Re: Groton Wind Farm, Revised Site Plans
SEC Docket No. 2010-01
Wetlands File No. 2010-00745
Alteration of Terrain Permit No. 100325-033

Project Revisions
Index Sheet

Project Revisions
 Sheet 1 of 2

Project Revisions
 Sheet 2 of 2

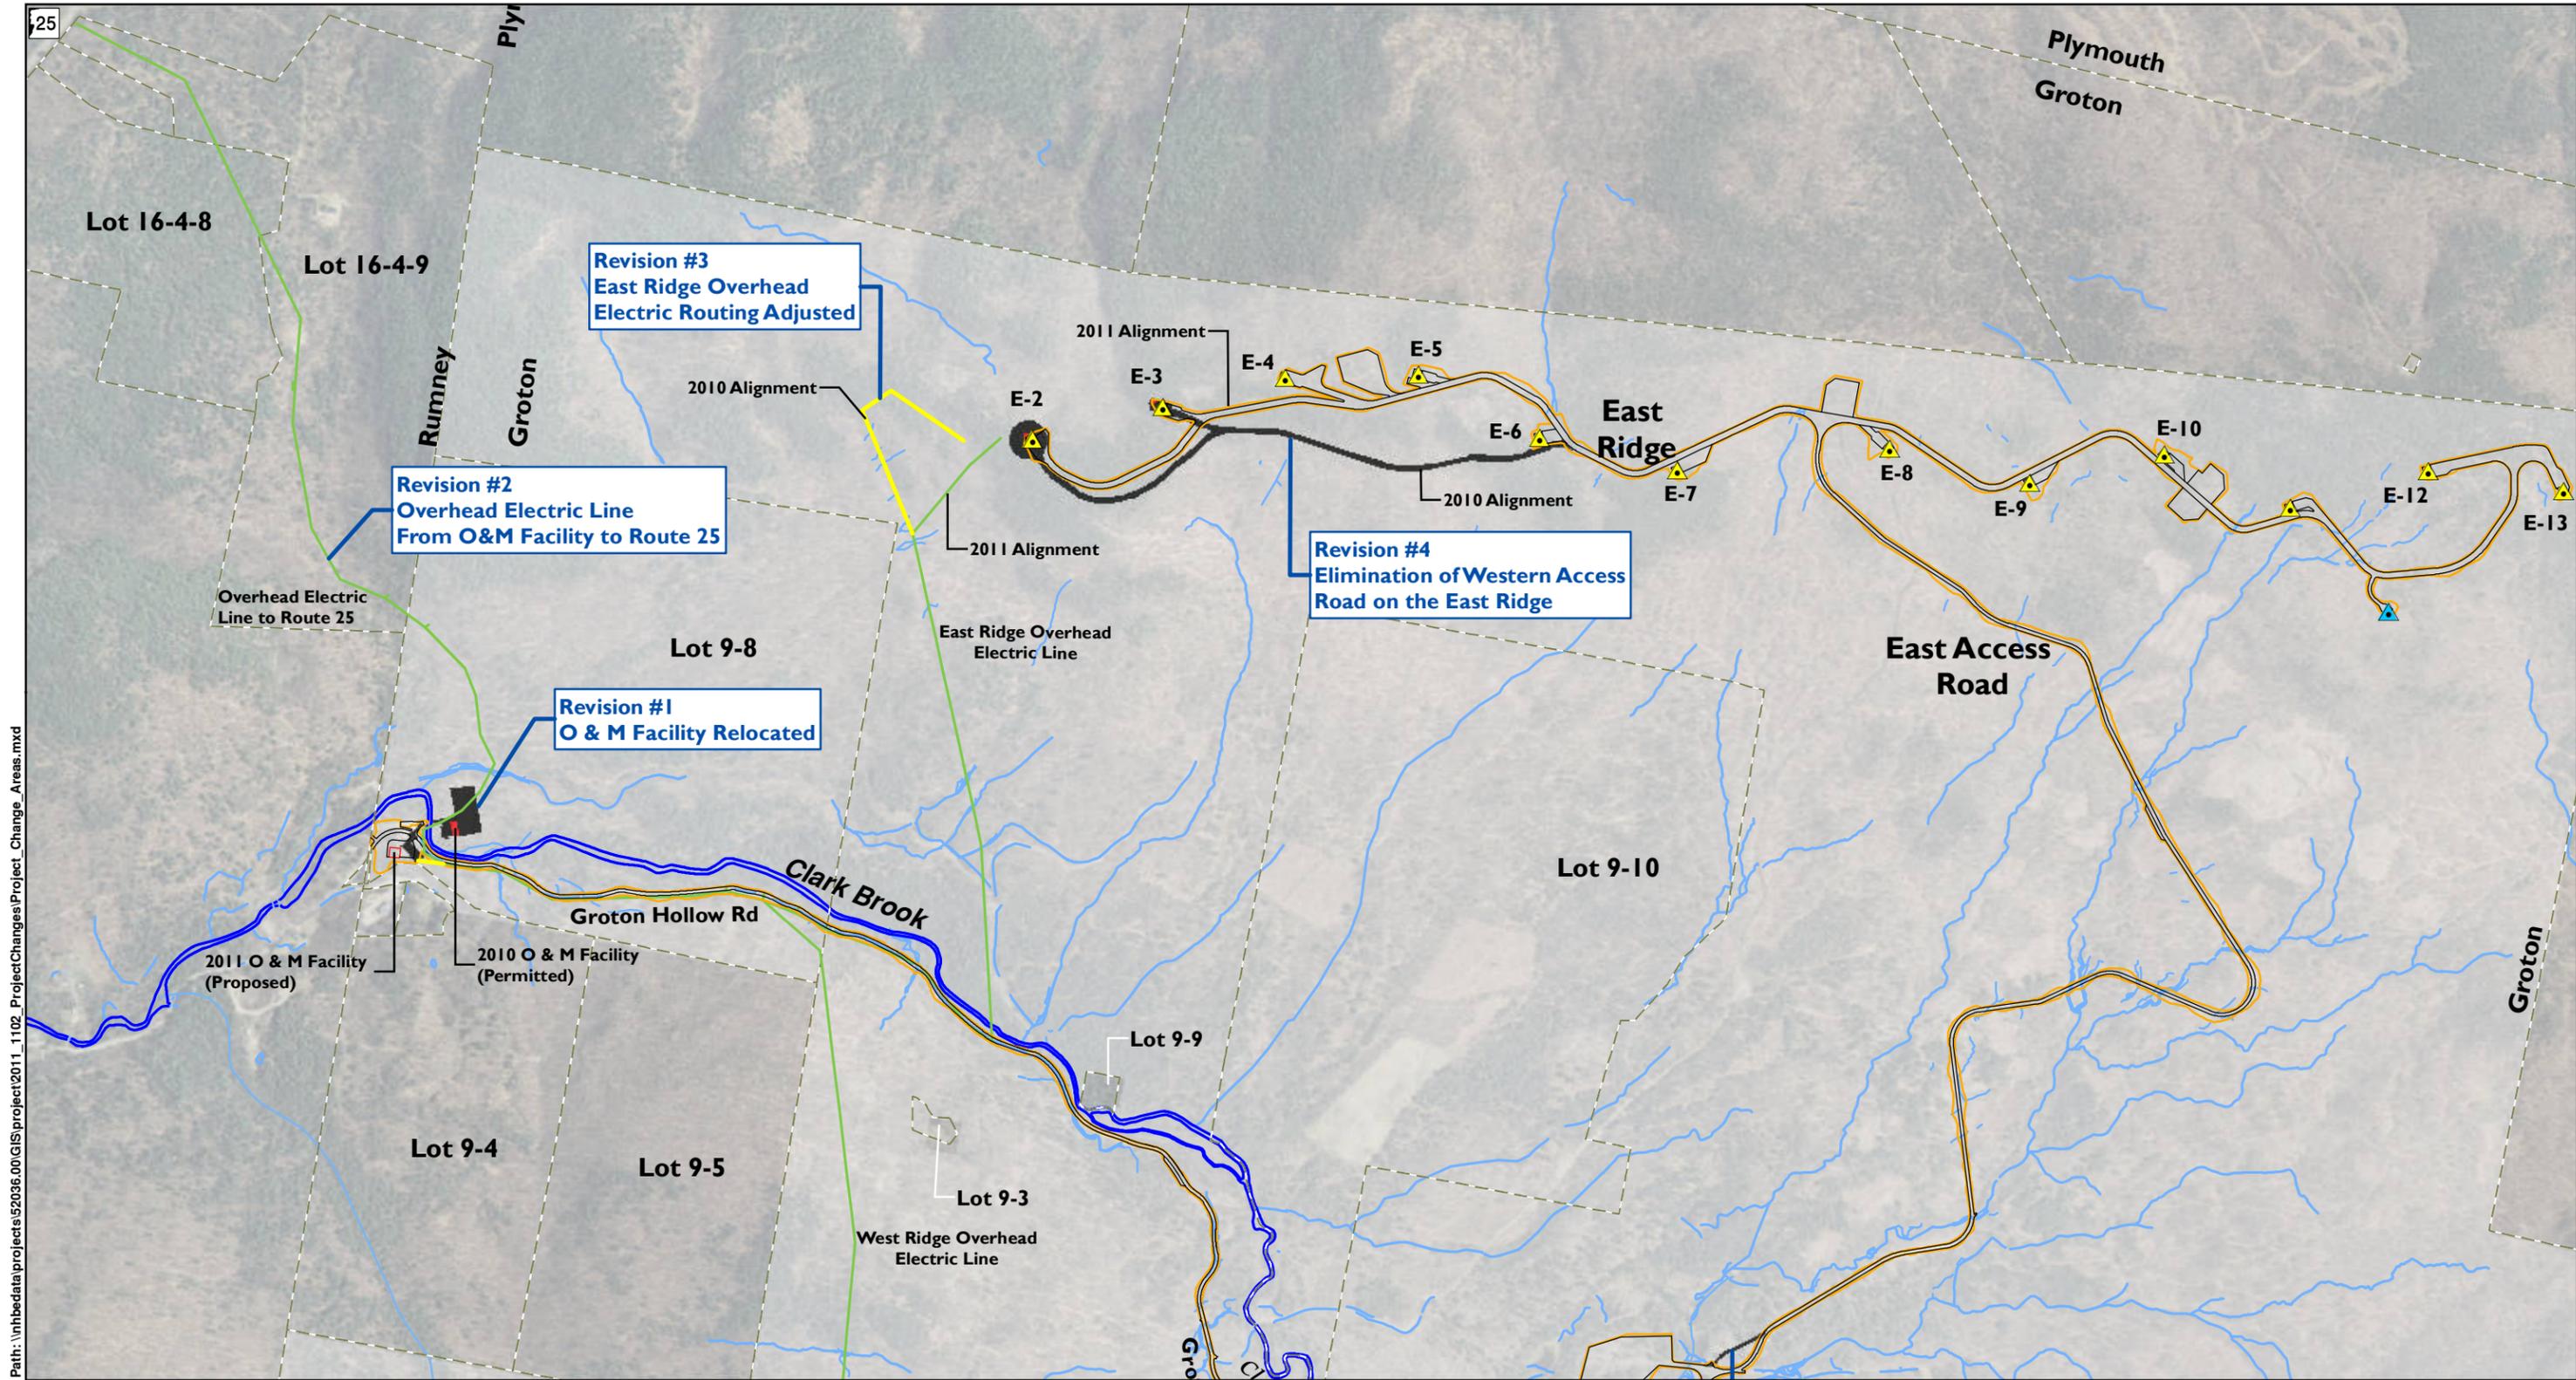
The Site Plans have been updated to show additional detail required for construction. In addition, eight revisions have been made to Site Plans relative to the July 9, 2010 plan set (i.e., the "Permitted Plans") as described below.

Each of the eight revisions is highlighted in the enclosed plan set and is further described below.

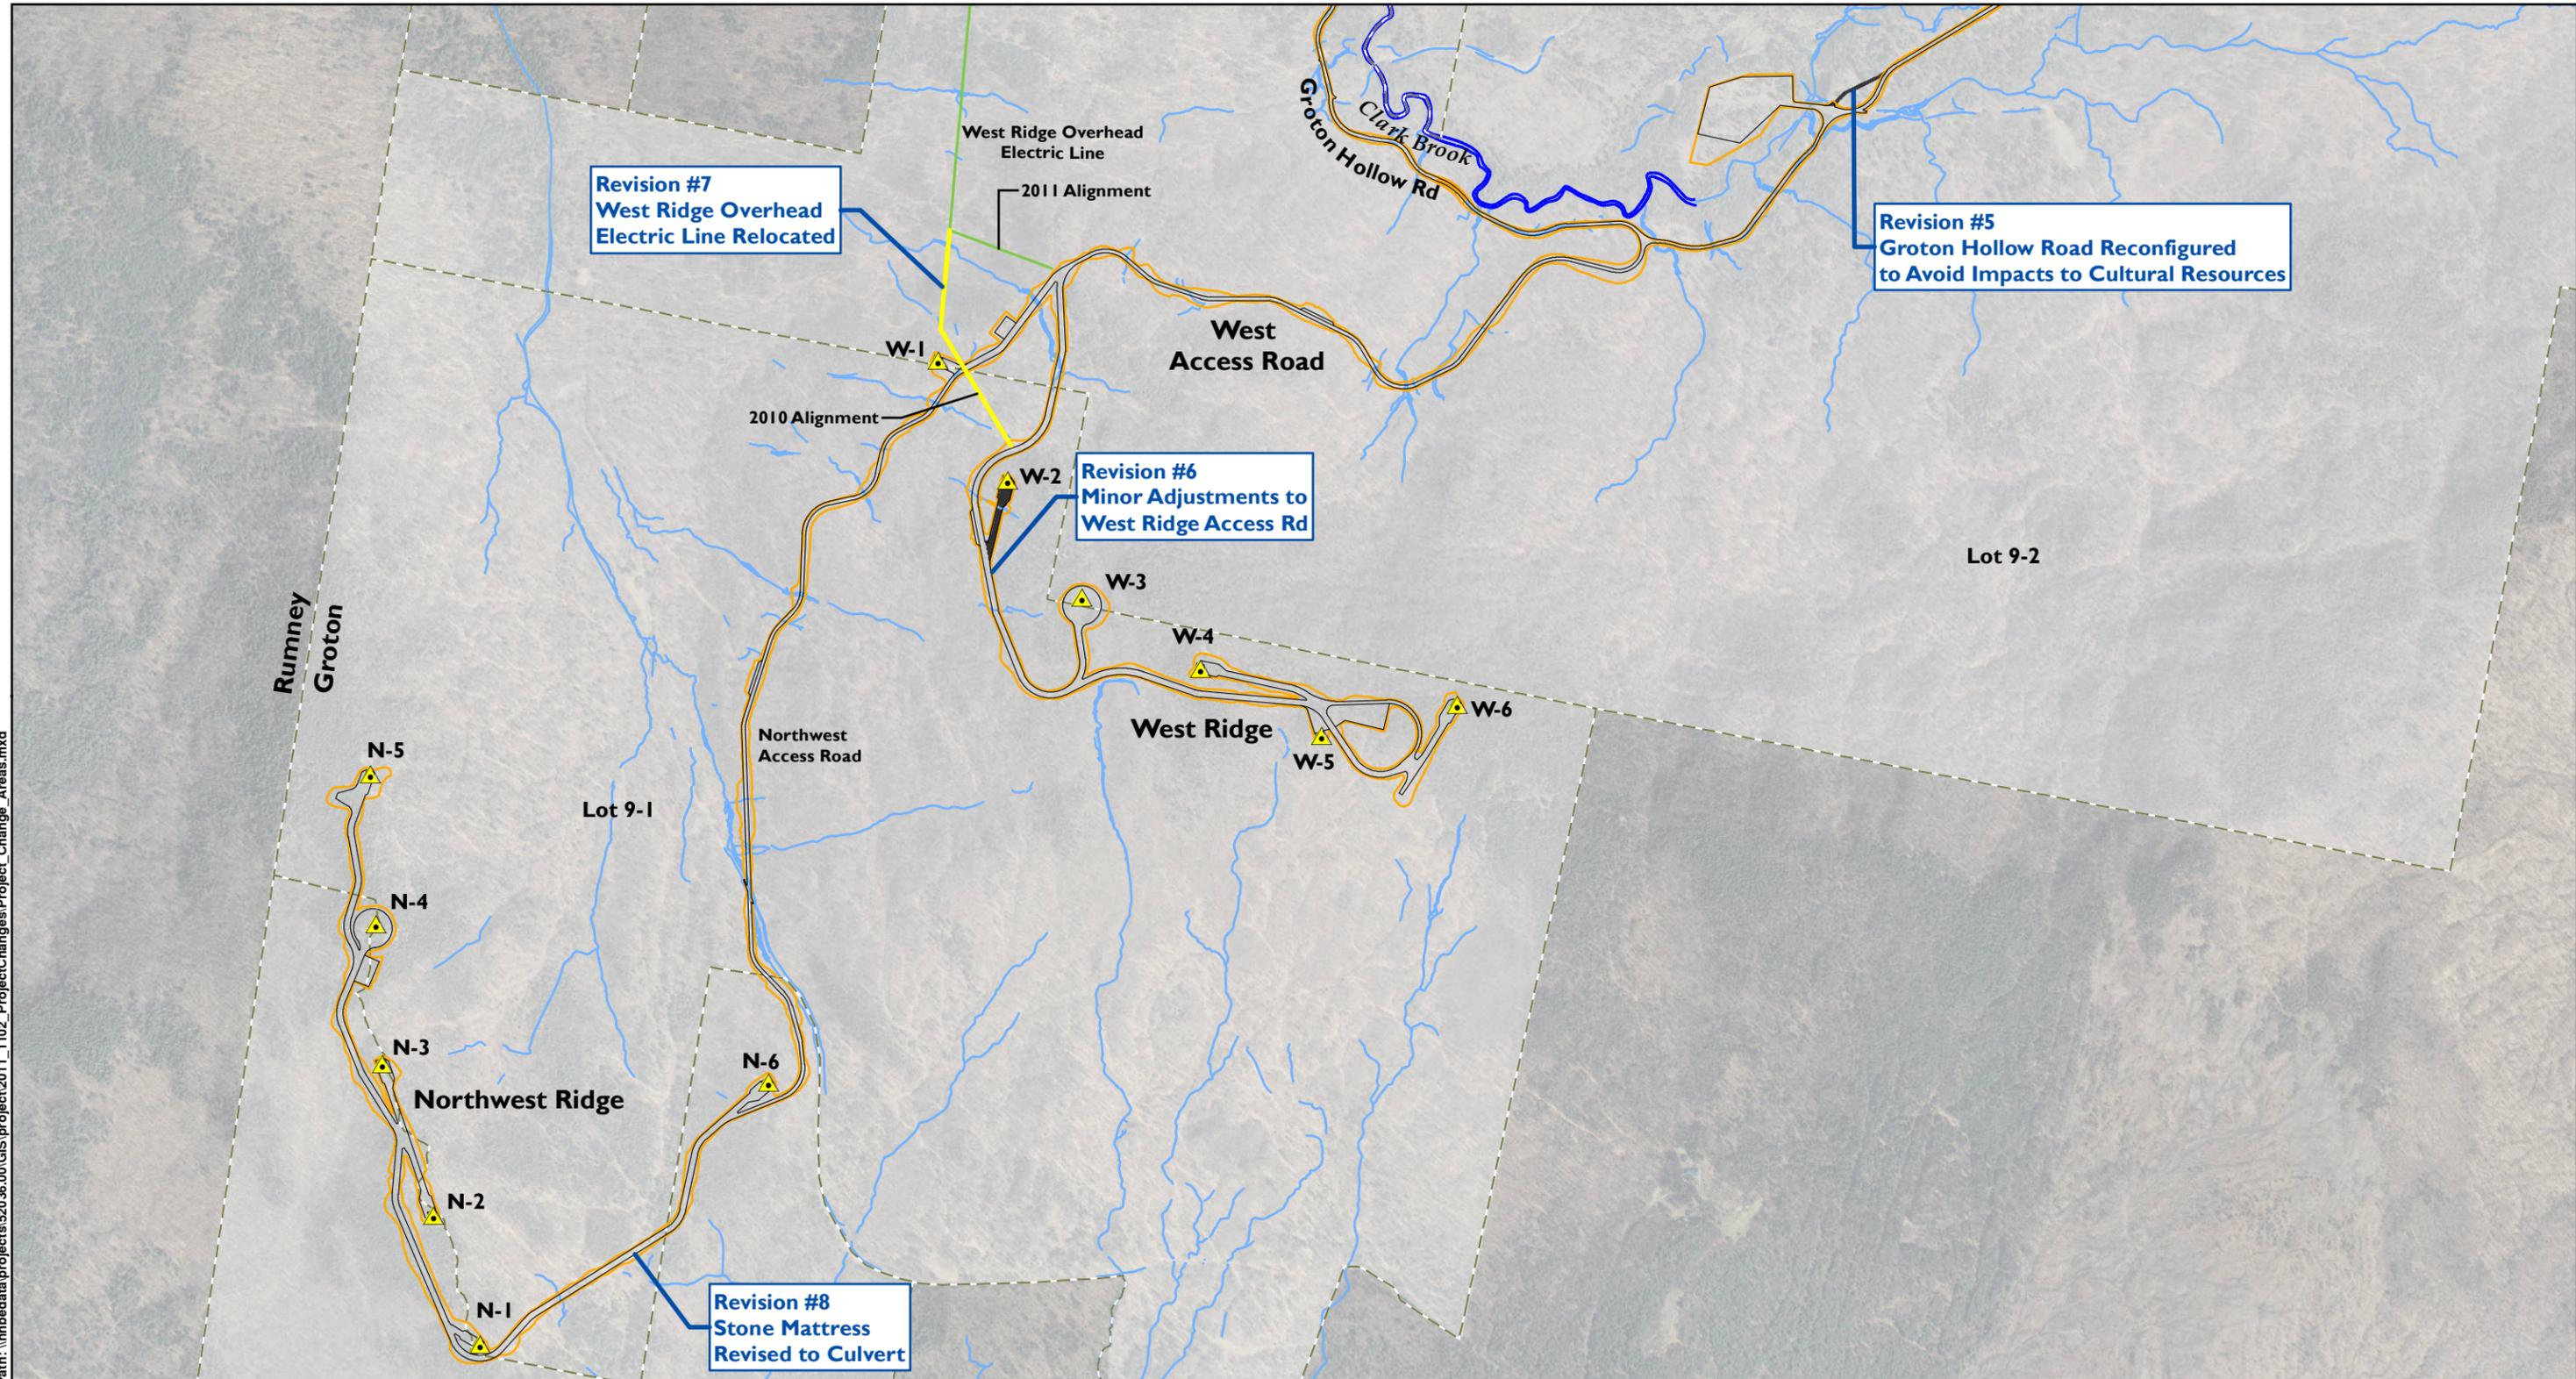
Revision 1. Operations and Maintenance Facility (Drawing C-3.1)

The proposed Operations & Maintenance (O&M) Facility has been revised. The O&M facility was moved from the east side of Clark Brook to the west side of Groton Hollow Road to a location where a fenced in switch yard was previously proposed. In addition, the total area for the O&M building and adjacent storage area has been reduced. Refer to Drawing C-3.1 for a plan showing the revised layout of the O&M area and to the enclosed Drainage Report Addendum for updated drainage calculations. This change has several environmental advantages:

Revision 2. Overhead Electric Transmission Interconnect (Drawing C-2.9, C-2.10 and C-3.1)

The overhead electrical transmission interconnect is now shown to run cross-country from the O&M Facility to NH 25. Refer to Drawings C-2.9, C-2.10 and C-3.1 for location of overhead transmission line from the O&M Facility to NH 25. As you know, the electricity from the wind farm will be transmitted to the grid along existing right-of-way except for a small portion from the site to existing NH Electric Cooperative poles that run along NH 25. Previously, the overhead line had been proposed to run north along Groton Hollow Road, but is now planned to run cross-country to NH 25 along property owned by Green Acre Woodlands, Patricia and Frederick Langford and Christopher and Therese Sheehan. This change was presented and approved as part of

Revision 3. East Ridge Overhead Electric Collector Line (Drawings C-2.6, C-5.1, C-5.2, C-5.3 and C-5.4)

A short segment of the overhead transmission line heading from Turbine E2 to the O&M Facility has been adjusted. This revision shortens the route and therefore decreases the amount of clearing on the East Ridge.

Revision 4. East Ridge Access Road (Drawings C-2.6, C-5.1, C-5.2, C-5.3 and C-5.4)

The access road and overhead electric line on the East Ridge has been revised. Previously, there were separate access roads to Turbines E4 and E5 and to Turbines E2 and E3. The access for the East Ridge has been combined into a single road that will reduce the length of road required to access these turbines. Turbines E2 and E3 were relocated very slightly as part of these changes. The new location of Turbine E3 and the revised road layout reduces the overall project footprint in this area, but does increase clearing within Vernal Pool ERVP1 and its buffer from 10,320 sq ft to 20,200 sq ft (See Impact #80, Sheet C-5.3). Other changes to the access road in the vicinity of Turbine E6 have resulted in a reduction in impacts to Wetland ER38 from 820 sq ft to 470 sq ft (See Impact # 73, Sheet C-5.1).
